**DELAWARE HOSPITAL FOR THE CHRONICALLY ILL
CANDEE BUILDING – 300 WING
TOILET ROOM & TUB ROOM RENOVATIONS
100 SUNNYSIDE ROAD, SMYRNA, DELAWARE 19977
DBF #586B031.W02 □ OMB/DFM# MC351400008
AUGUST 29, 2013**

ADDENDUM NO. 1

A9.1

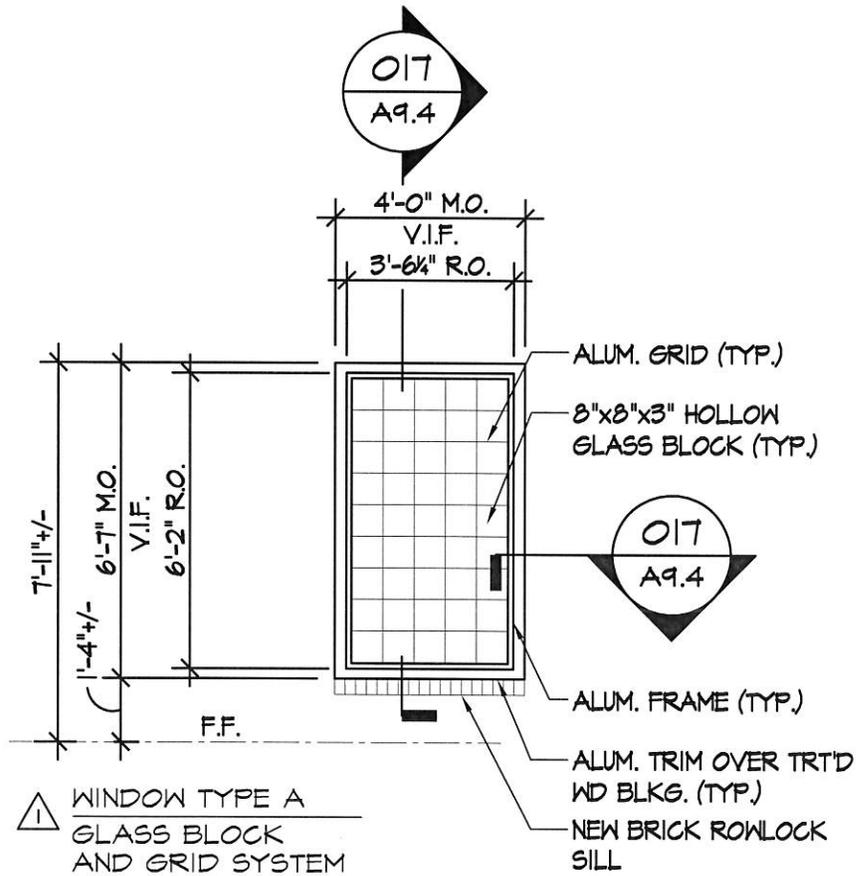
1. THIS SHEET MODIFIES DEMOLITION PLAN JI ON SHEET A1.

A9.2

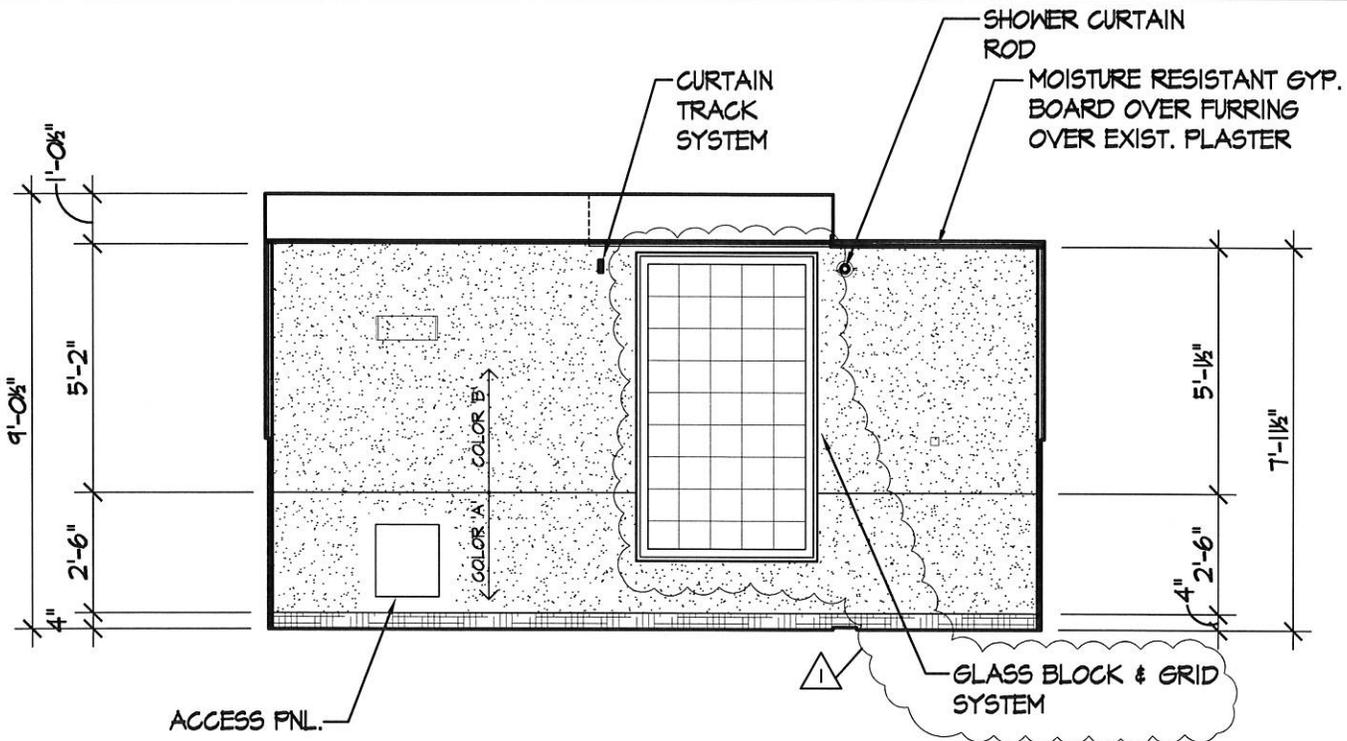
1. THIS SHEET MODIFIES WINDOW TYPE A ON DETAIL D14 ON SHEET A2.

Dwg. No.:
A9.3

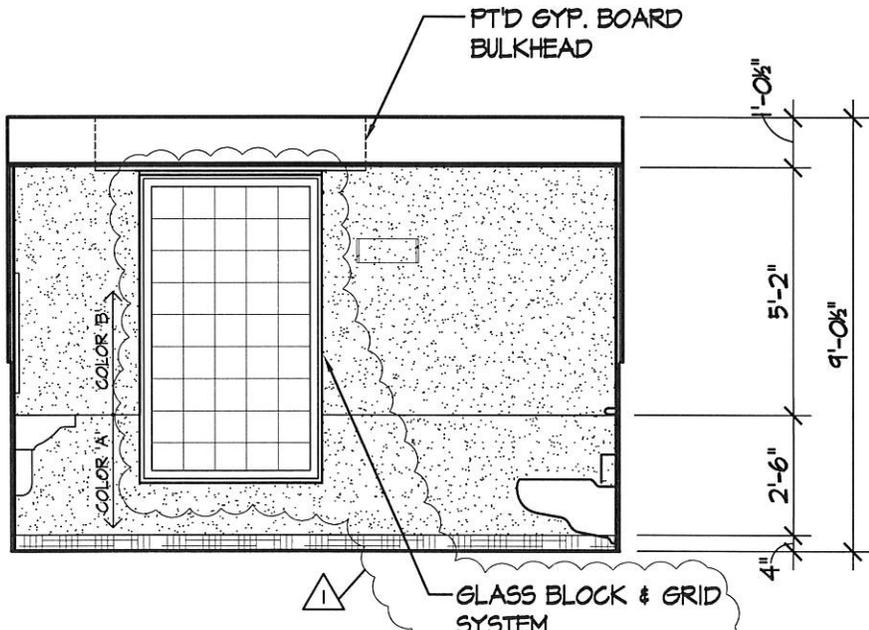
1. THIS SHEET MODIFIES INTERIOR ELEVATIONS OI-D AND OI-F ON DETAIL OI ON SHEET A2.

A9.4

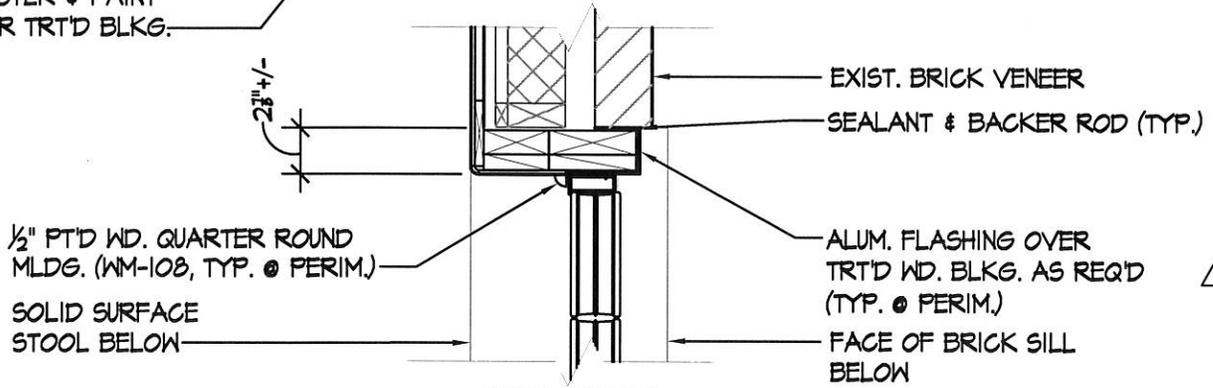
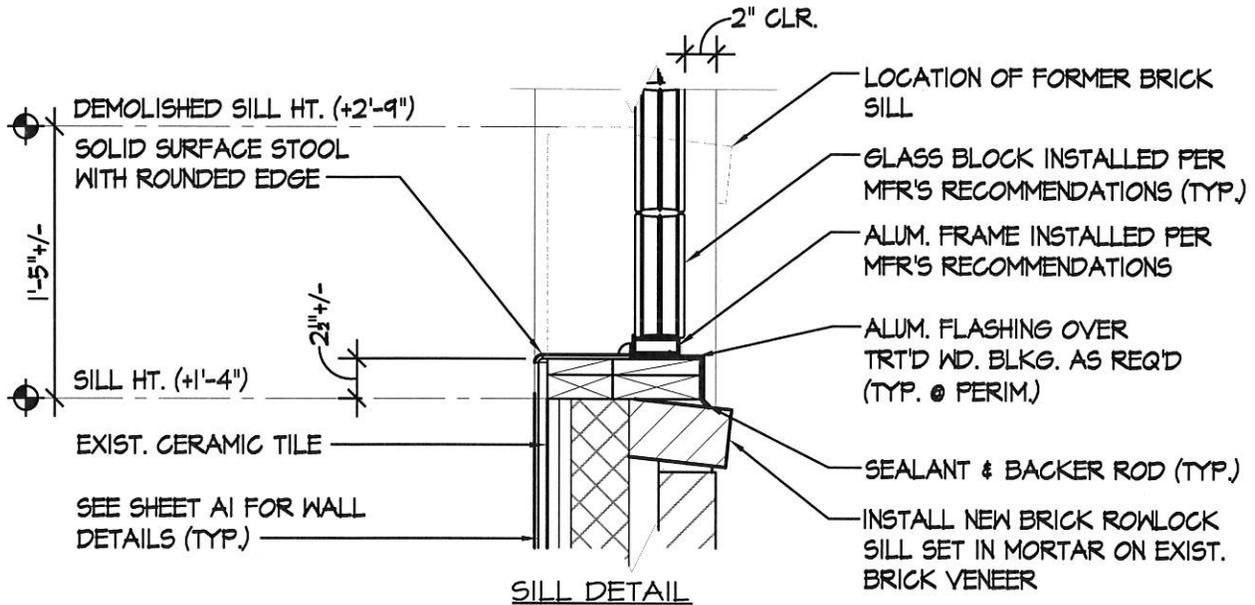
- THIS SHEET MODIFIES WINDOW DETAILS H17 ON SHEET A2.
